## SERVICE BULLETIN

**NUMBER:** 16-112-18R

**SUBJECT:** Ignition Key Sticking / Design Change to CVT Shifter / Selector Lever Components

**For Legacy and Outback:**

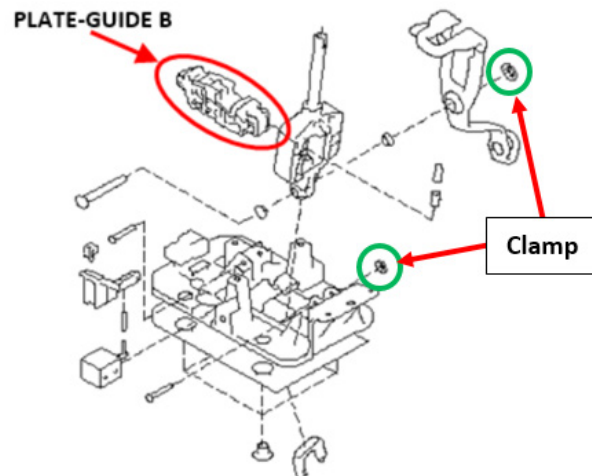
- The term PLATE-GUIDE B refers to the Park-Range switch which is a serviceable part of the select lever assembly on all models listed above **EXCEPT** Legacy and Outback. See the illustrations provided below for more details.
- For **Legacy and Outback**, the shifter assembly (SELECT LEVER COMPLETE) must be replaced if the Park-Range switch is found to be faulty.

- Replace the SELECT LEVER COMPLETE assembly (on Legacy and Outback models) or,
- Replace the Park-Range switch (PLATE-GUIDE B) following the Select Lever disassembly / assembly procedure in the applicable Service Manual.

<b>Figure 2</b>		
P SW	P range switch ON/OFF status. Body integrated unit input value. Set to ON in the P range.	ON/OFF

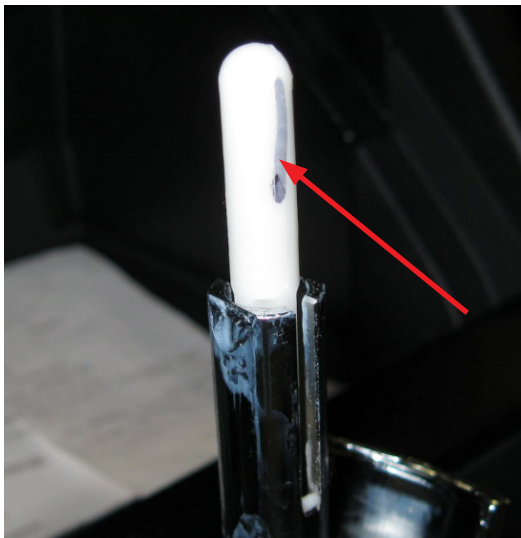
- If the Key lock solenoid output is displayed as **Lock**, the next step in diagnosis should be to check the following PID (Figure 2 below).

- P SW is the park range switch, located in the AT shifter assembly. If the shifter is in the Park position and this PID remains OFF, suspect an issue with either the park range switch or the related wiring. Check for drink spills, previous interior repairs, modifications and the shift lever position itself. Troubleshooting procedures can be found in the applicable Service Manual under the AT Shift Lock Control System > KEY INTERLOCK CANNOT BE LOCKED OR RELEASED.
